Response to
Request for Additional Information No. 248, Supplement 3

U.S. EPR Standard Design Certification
AREVA NP Inc.
Docket No. 52-020
SRP Section: 03.04.02 - Analysis Procedures
SRP Section: 03.07.01 - Seismic Design Parameters
SRP Section: 03.07.02 - Seismic System Analysis
SRP Section: 03.08.01 - Concrete Containment
SRP Section: 03.08.03 - Concrete and Steel Internal Structures of Steel or
Concrete Containments
SRP Section: 03.08.04 - Other Seismic Category I Structures

Application Section: FSAR Ch 3

QUESTIONS for Structural Engineering Branch 2 (ESBWR/ABWR Projects) (SEB2)

Figure 3.7.2-43-1—Comparison of the Responses at the Top of the Basemat

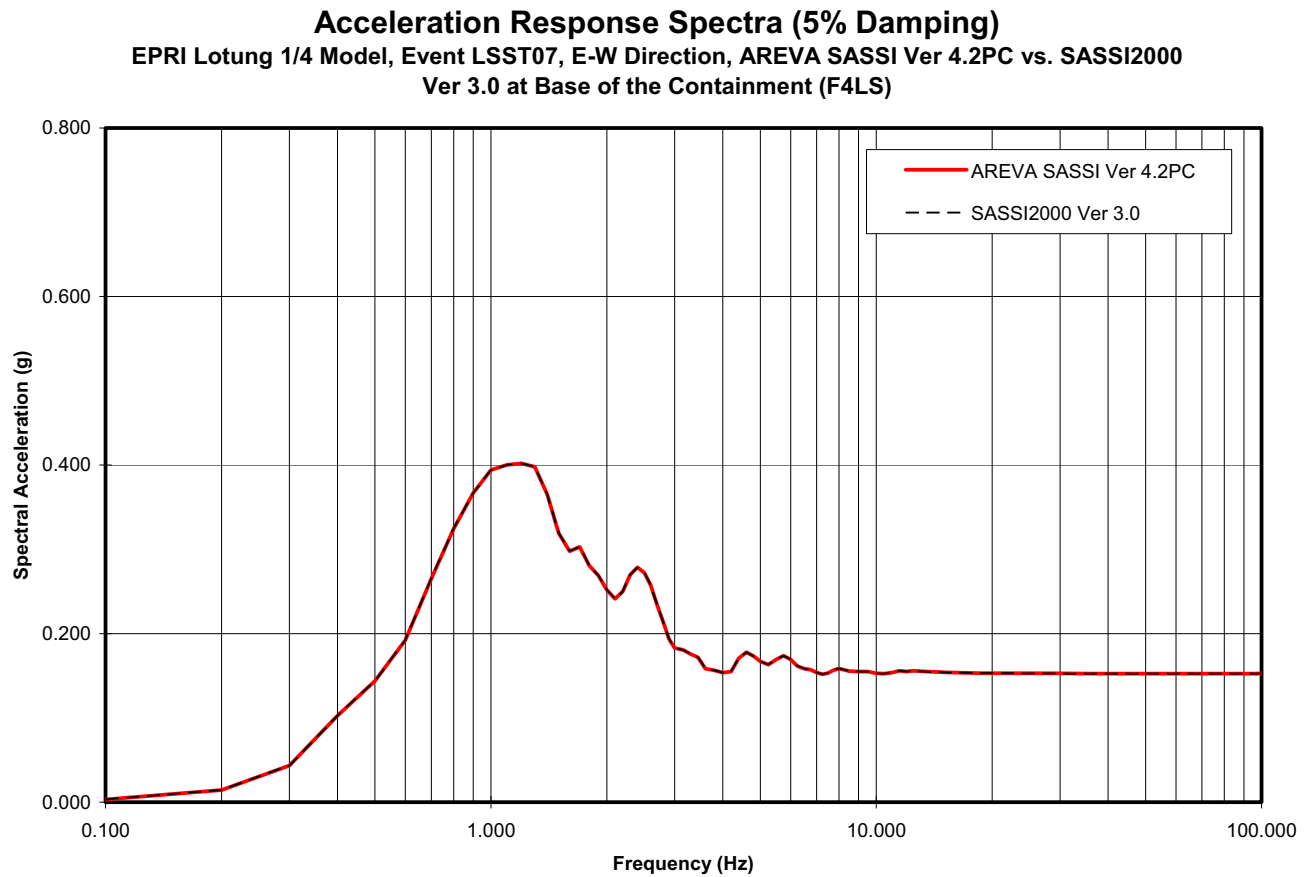
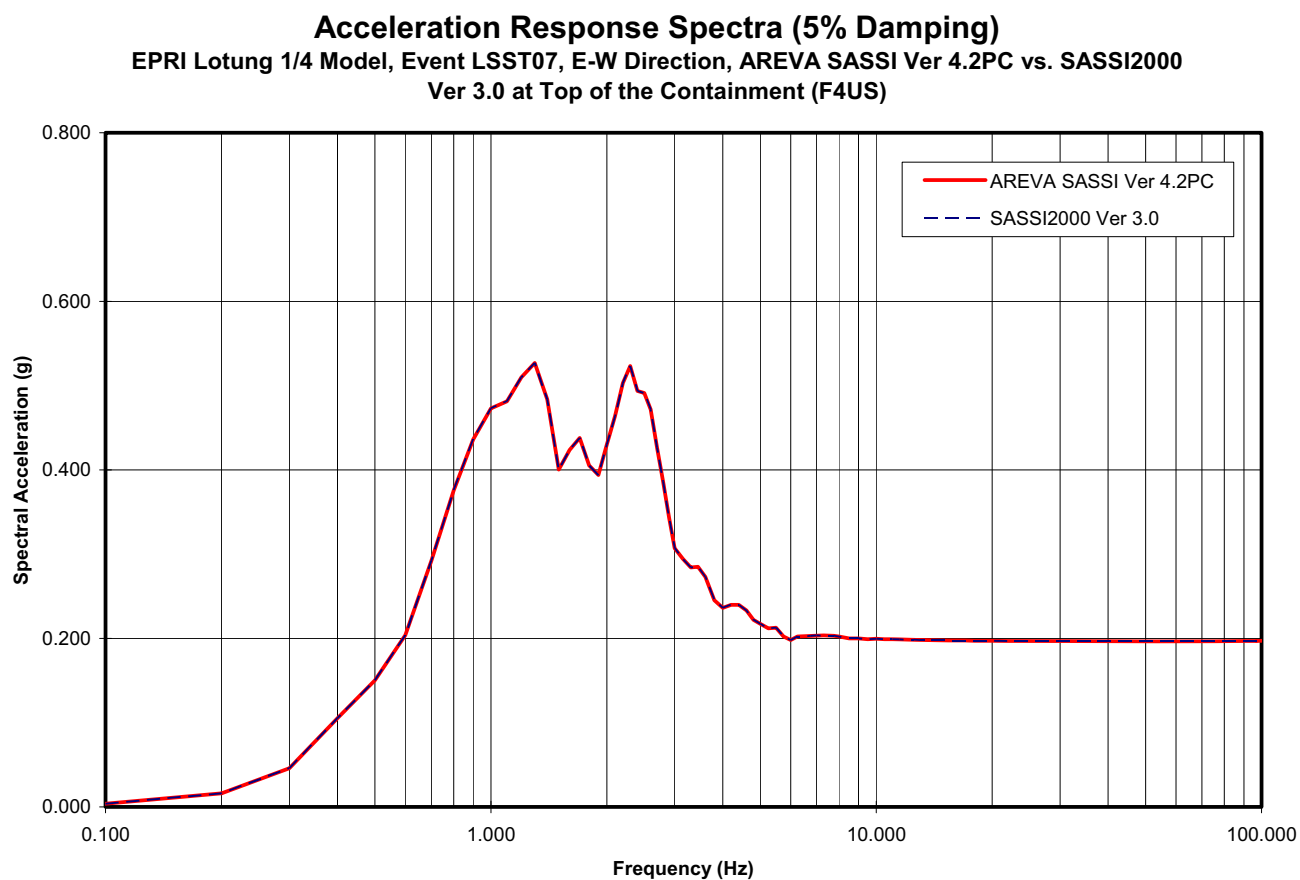
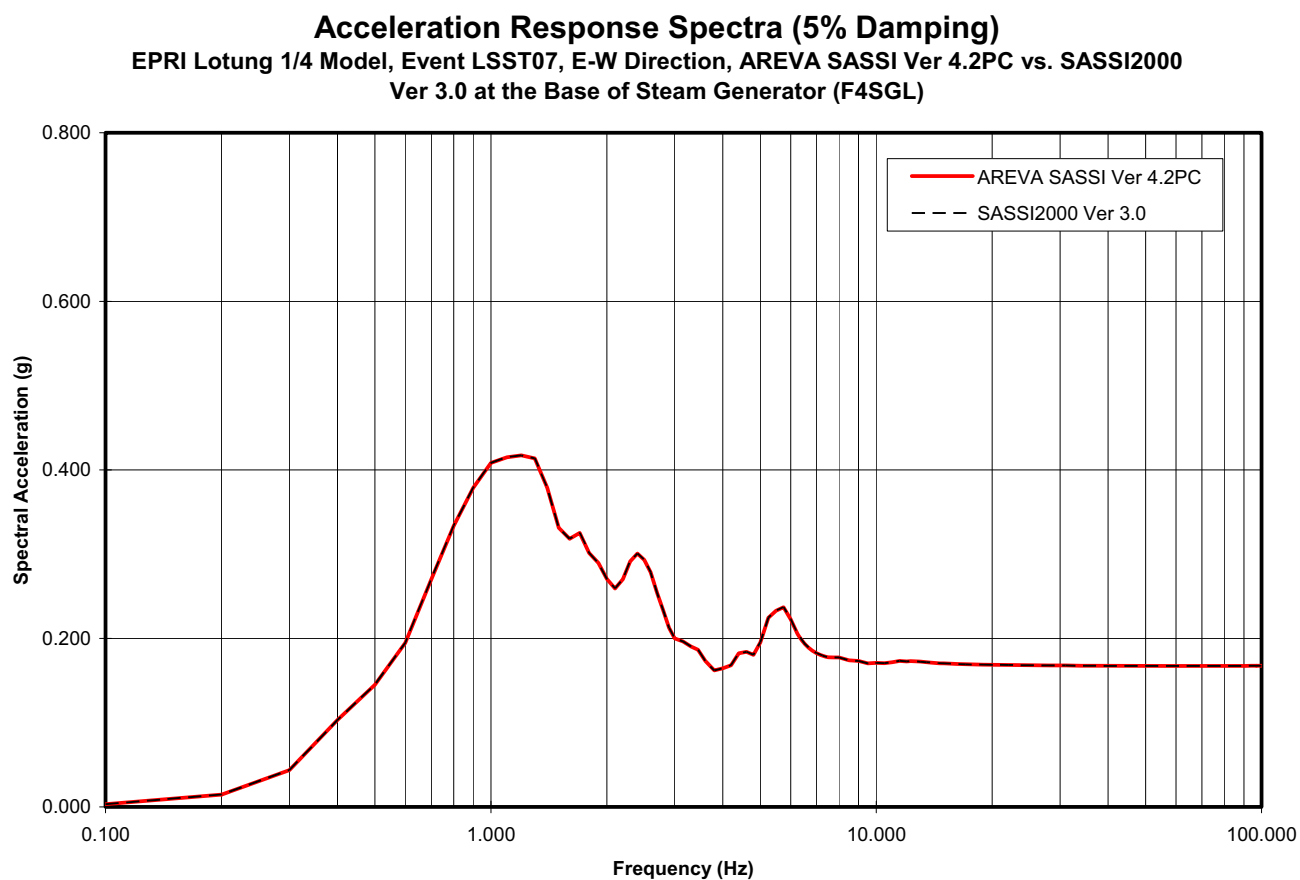
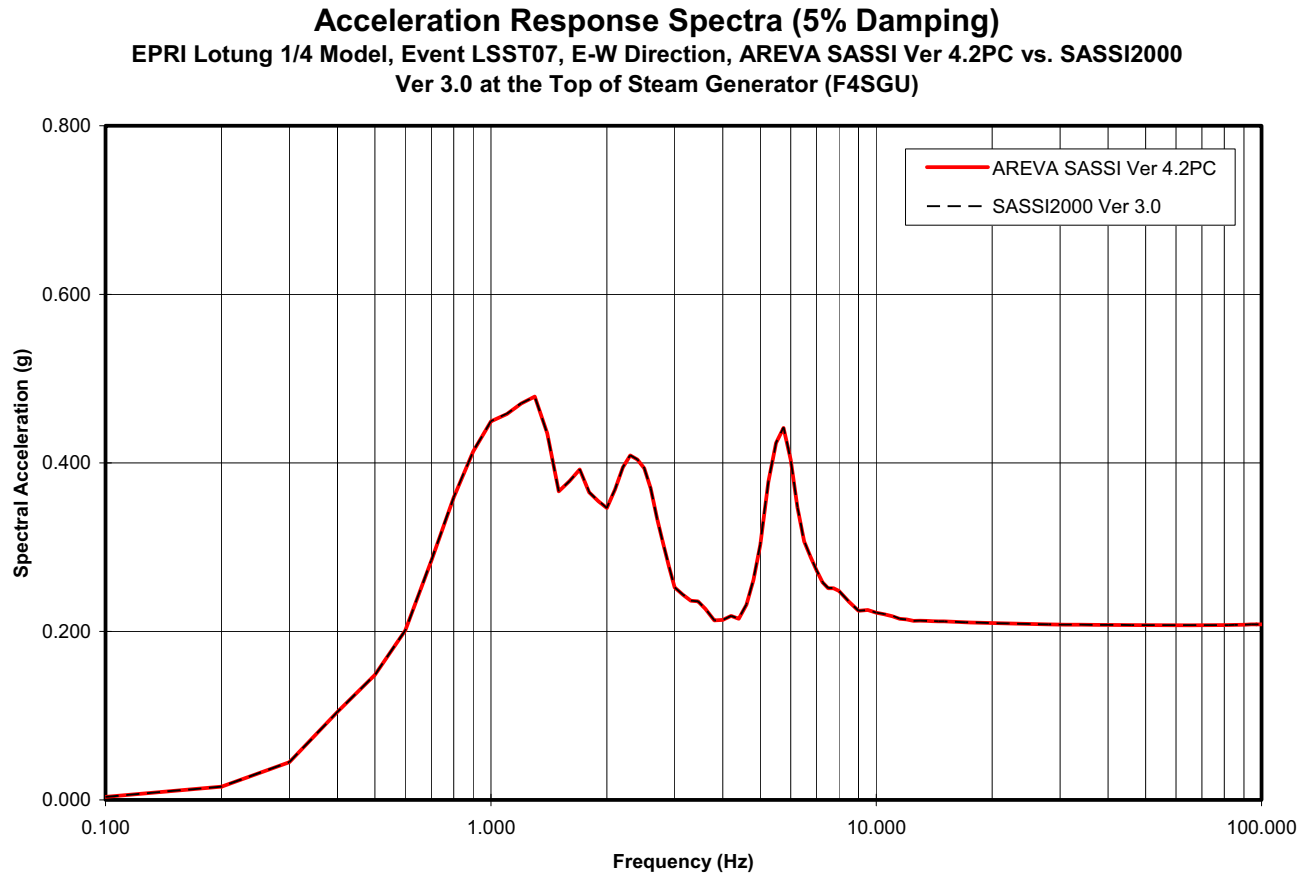
The response states that the two versions of the code are functionally the same and produce equivalent results with no significant differences. However, it does not provide a comparison of results from a building seismic analysis using the two versions (AREVA SASSI v. 4.1B and Bechtel SASSI2000, v. 3.1) as requested in Question 03.07.02-1. Because each code is being used in the analysis of Seismic Category I structures, it should be demonstrated that the codes provide similar results for the SSI analysis. The applicant is requested to run an analysis of an embedded seismic Category I structure using both versions of the code and demonstrate that the seismic response of the structure is similar for each of the programs.

SASSI analysis results, in terms of 5 percent damped acceleration response spectrum at four structure locations, are computed and compared with other results (i.e., SASSI2000 Version 3.0). The four containment locations are 1 point at the top (Node 311 in SASSI model) of containment and 1 point at the base (Southern end, Node 178), plus 1 point at the top steam generator platform support and 1 point at the lower steam generator platform support (Nodes 302 and 300, respectively). Model details are available in References 1 and 2.

Acceleration response spectra of motions recorded at these four points are compared with AREVA NP SASSI, Version 4.2PC in Figures 3.7.2-43-1, 3.7.2-43-2, 3.7.2-43-3, and 3.7.2-43-4. Acceleration-time histories are obtained by running the MOTION module of SASSI, and the response spectra are generated using AREVA NP RESPEC, Version 1.2PC code. Results show that structural seismic responses calculated by the two programs are comparable.
